KSS Knit Composite Ltd. (Extension Buildings)

Boherar Chala, Sreepur, Maowna
(24.200929, 90.401977)
29 May 2022

Observations

Mat Details

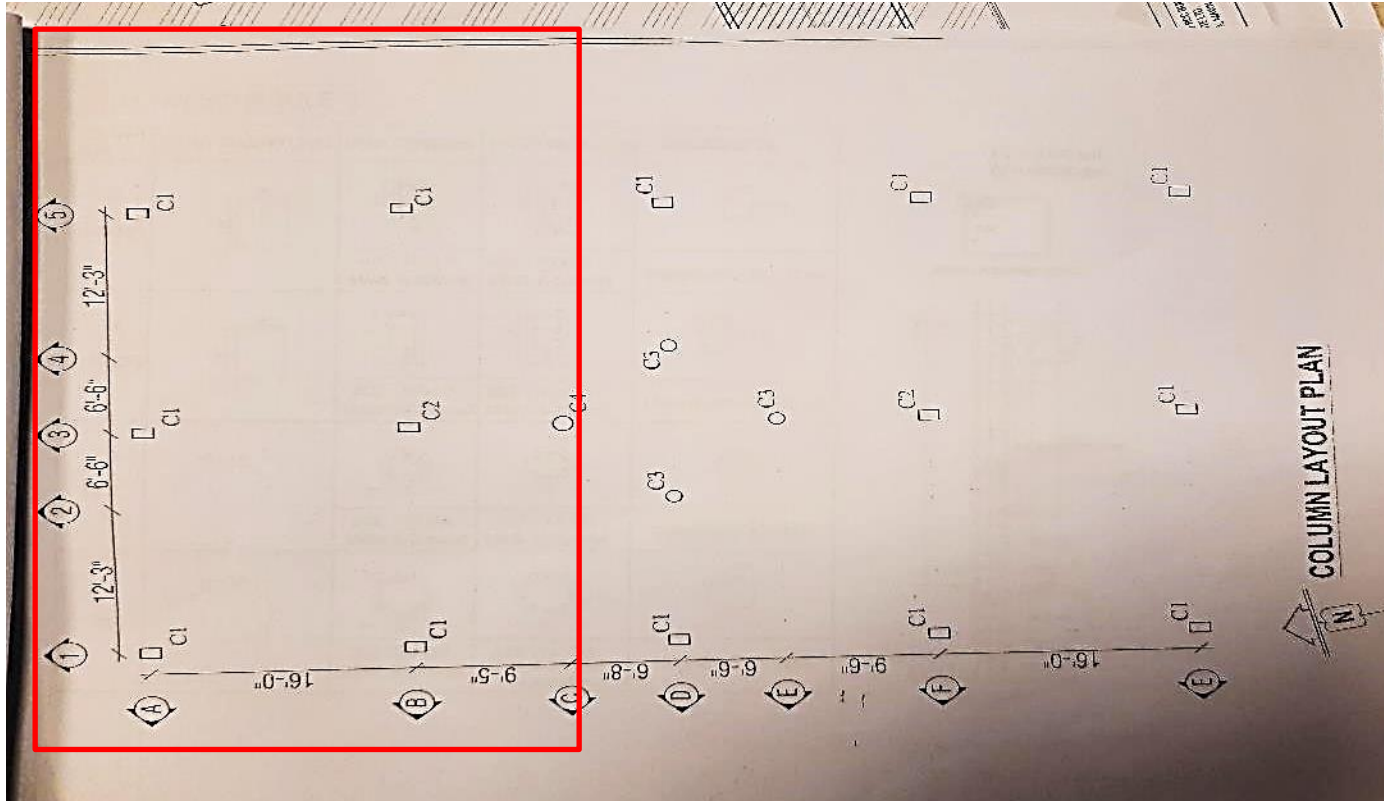
Preliminary calculations indicates high punching shear stresses on the footing considering the minimum concrete strength of brick chips aggregate & prepared live load plan of 3 kPa. A Detail Engineering Assessment is required to carry out by the Building Engineer.

| Item No. | Observation | Recommended Action Plan | Recommended Timeline |
|----------|--|--|----------------------|
| 01 | Preliminary calculations indicate high punching shear stress in footing. (Building-04) | Building Engineer to review design, loads and punching shear stresses. | Immediate - Now |
| 02 | Preliminary calculations indicate high punching shear stress in footing. (Building-04) | Verify in-situ concrete strengths (using 100mm dia. cores min 4 nos). | Immediate - Now |
| 03 | Preliminary calculations indicate high punching shear stress in footing. (Building-04) | A Detail Engineering Assessment to be commenced. | Immediate - Now |

Observation: Fire Hydrant Building (Building-06)

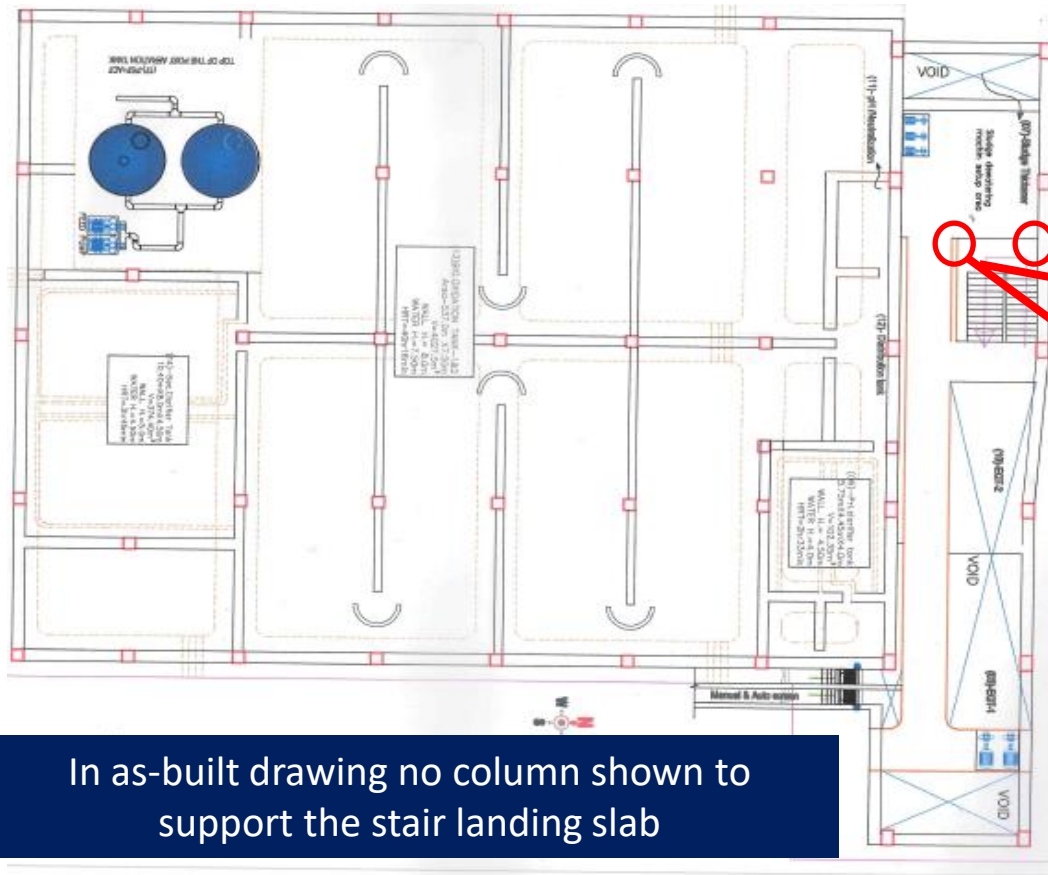
Damp area observed at staircase and several place due to water leakage. Building engineer is required to provide remedial measure to repair the damped areas.

| Item No. | Observation | Recommended Action Plan | Recommended Timeline |
|----------|---|---|----------------------|
| 20 | Dampness in several locations. (Building-06) | Building engineer is required to provide remedial measure to repair the damped area. | 6-weeks |
